APPROVING A LOT LINE MERGER FOR
LOTS 7 AND 8, NORWOOD TECH BUSINESS
PARK (P84-184)

CITY PLANNING COMMISSION

- APPLICATION:
1. Negative Declaration
 2. Special Permit to develop two office/warehouse structures on 4± vacant acres in M-1(S)(PUD) and (HC-PUD) in Norwood Tech Business Park
 3. Lot Line Adjustment to create 4± acre parcel to allow two office/warehouse structures totaling approx. 60,000 square feet

LOCATION: North side Opportunity Street, bet. Development and Research Drives

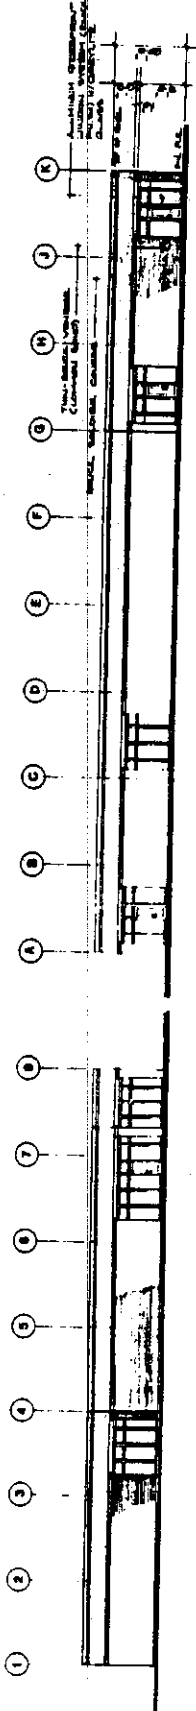
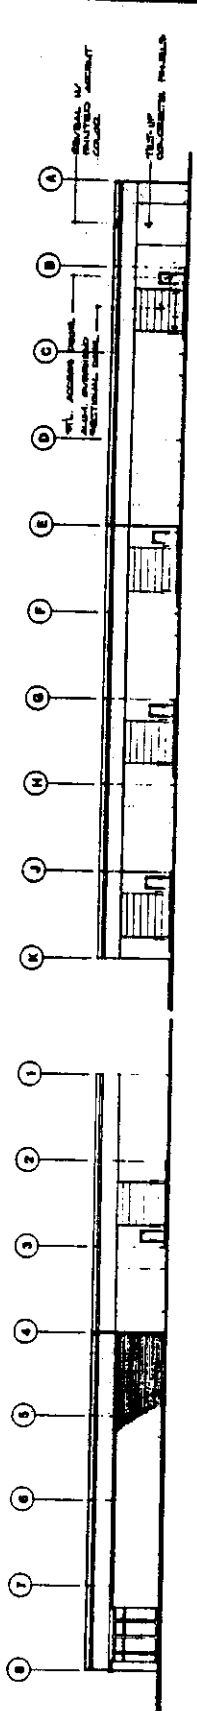
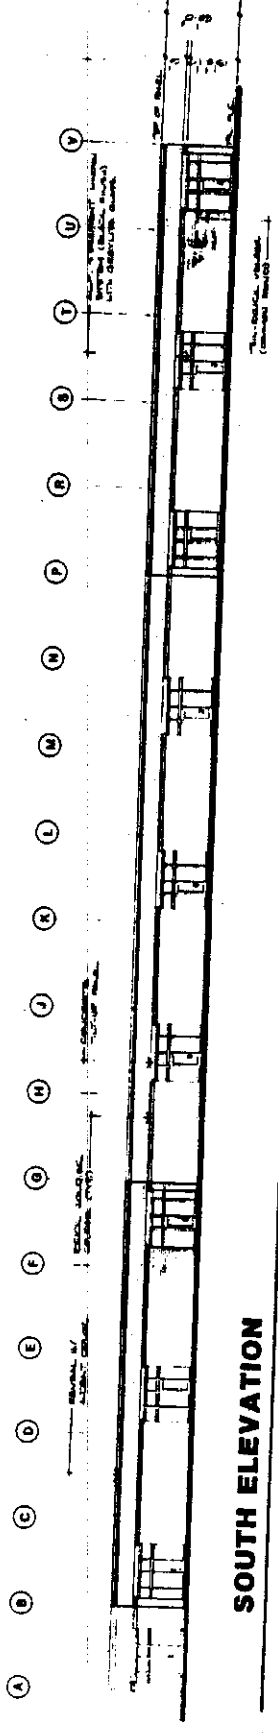
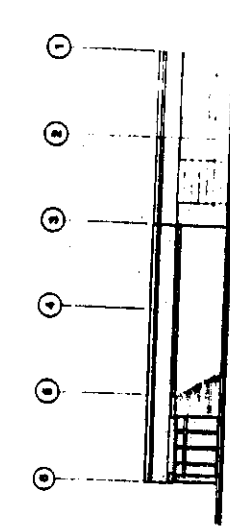
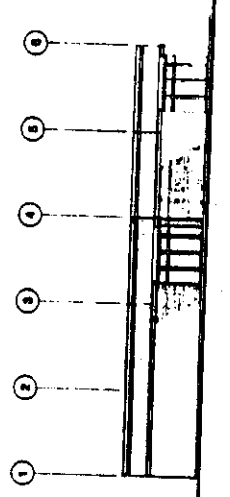
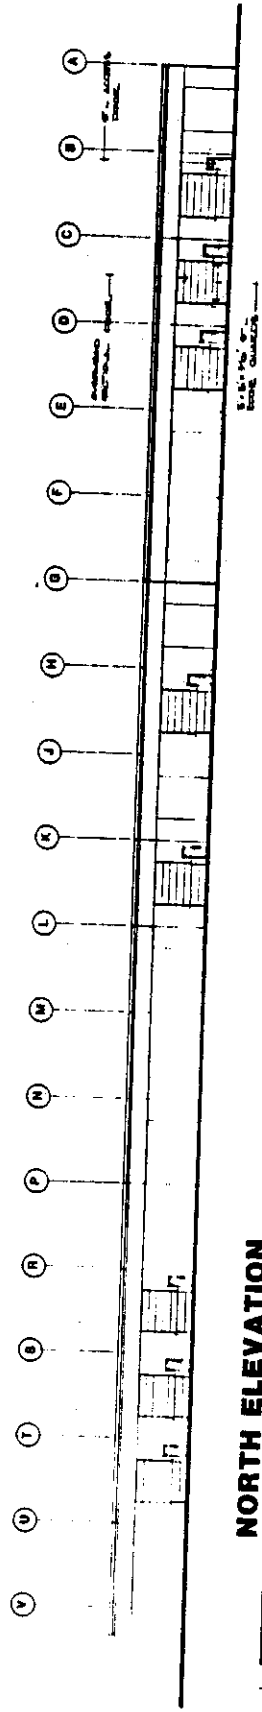
The project, as designed, does not meet the objective of the PUD, "to preserve and enhance the aesthetic values throughout the project." Furthermore, the guidelines require that finished building materials shall be applied to all sides of the building which are visible to the general public, and occupants of the same and other buildings. Again, a redesign is necessary to comply with these guidelines.

8. The freeway side of both buildings has an architectural treatment different from the front elevations. The contrast is most apparent at those corners of the building where the brick ends and the concrete tiltup begins. The loading areas at the rear of the buildings will be typical of other warehouse buildings in non-PUD areas in the City.

- 5) a minimum 50-foot setback shall be provided for both buildings, from the freeway and drainage canal boundary;
 - 6) the buildings shall comply with the adopted PUD guidelines and provide finished building materials applied to all sides of the buildings;

FLOOR PLAN 1/16" = 1'-0" 0 50

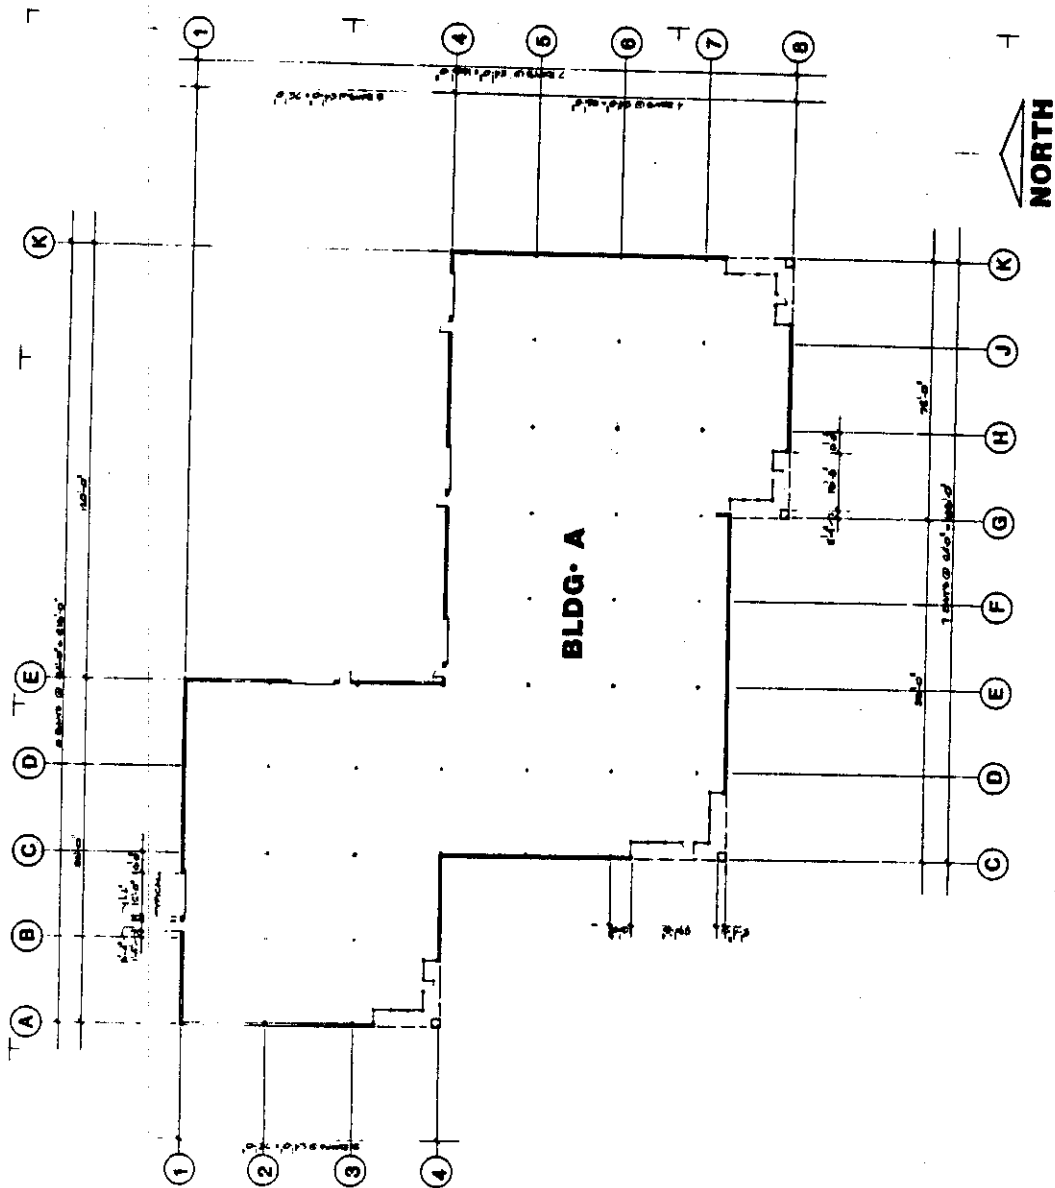
Traffic: Less paving would be required if the auto parking at Building B used separate driveway entrances (540 sq. ft. vs 3,000 sq. ft.) The western-most driveway need be only 25' - 30' wide if it serves only automobiles.

Electrical: The western edge of the proposed driveway at Development Drive should be moved easterly by at least five feet so it will not be in conflict with the existing street light.

4. Access to the rear of Building A is via the adjacent parcel. The parking spaces at the east end of Building A straddle the property line. These spaces should be located on either one or the other parcel. The required parking for each building should be provided as nearly as possible entirely on their respective parcels. A reciprocal parking and access agreement should be provided for review and approval prior to issuance of building permits.

5. There is virtually no landscaping at the rear of the buildings. The approved schematic plan indicates a continuous on-site landscaped strip along the freeway. Only about one-third of the freeway footage is now proposed for landscaping. Landscaping in the front setback is inadequate. The PUD Guidelines and schematic plan provide for a minimum landscape setback of 25 feet. Only 15 feet is proposed. Revised plans should be provided for review and approval prior to building permit approval.

6. The two-foot overhang area of the parking spaces should be incorporated into the adjacent landscape, or walkway improvement, in accordance with the PUD Guidelines (except for handicape spaces).

7. A minimum 50-foot setback from the freeway and drainage canal is required for Lots 8 and 9. Both Buildings A and B as shown are 20 feet at their closest point. A redesign of the building is necessary to meet the required setbacks.

- 1) locate parking spaces for Building A on either one parcel or the other. The required parking for each building shall be provided as nearly as possible entirely on their respective parcels;

- 2) submit a revised landscape plan that provides continuous on-site landscaping strip at least four feet wide along the north property line adjacent to the freeway and drainage canal; and

- 3) provides minimum 25-foot landscaped setback along the front property line;
 - 4) the two-foot overhang area of the parking spaces shall be incorporated into the adjacent landscape or walkway improvement;

- 7) location and design of trash enclosure structures;
 - 8) the western edge of the proposed driveway at Development Drive shall be moved easterly so it will not be in conflict with the existing street light.
